555 Davenport and 500 Macpherson Ave– proposed 8 storey / 10.906 square meter residential development

**TARRAGON
VILLAGE
COMMUNITY
ASSOCIATION**

BACKGROUND – PLANNING POLICIES REVIEW AND POTENTIAL NEGATIVE IMPACT

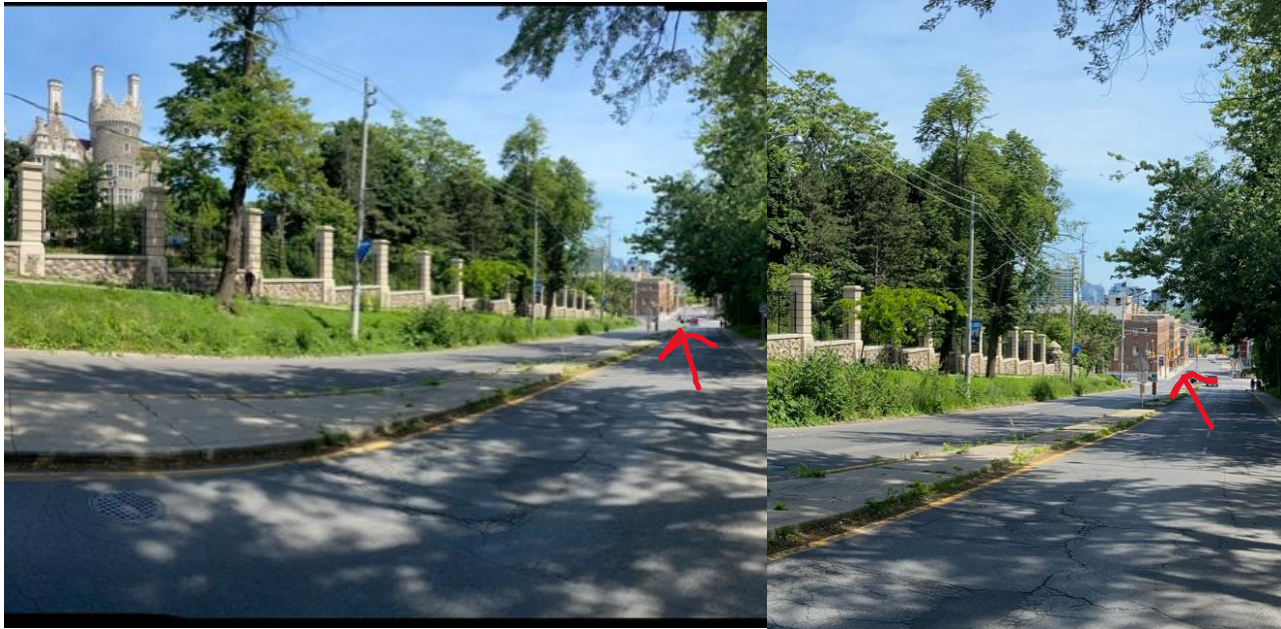
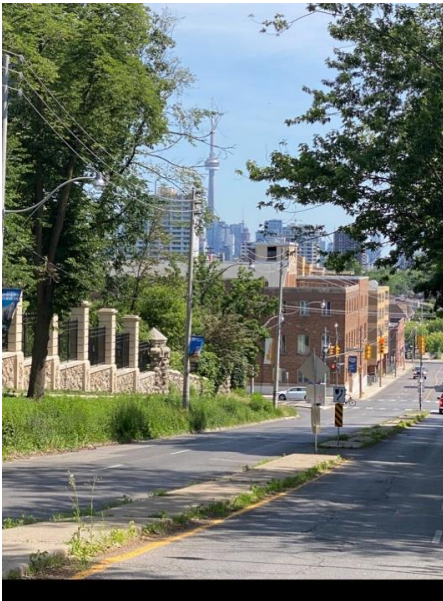
The following pictures taken at the top of Walmer Road adjacent to Casa Loma and Casa Loma grounds and the former home and private park built by EJ Lennox – the architect of Casa Loma and Old City Hall. This is a walk frequented by the many visitors to Casa

Loma and public walking tours of the Casa Loma heritage neighbourhood and thus can be considered a “Scenic Route” as defined in Policy 22. It can be seen that the views and vista to the City skyline and CN Tower would be seriously irreversibly diminished by the increased height proposed at 555 Davenport.
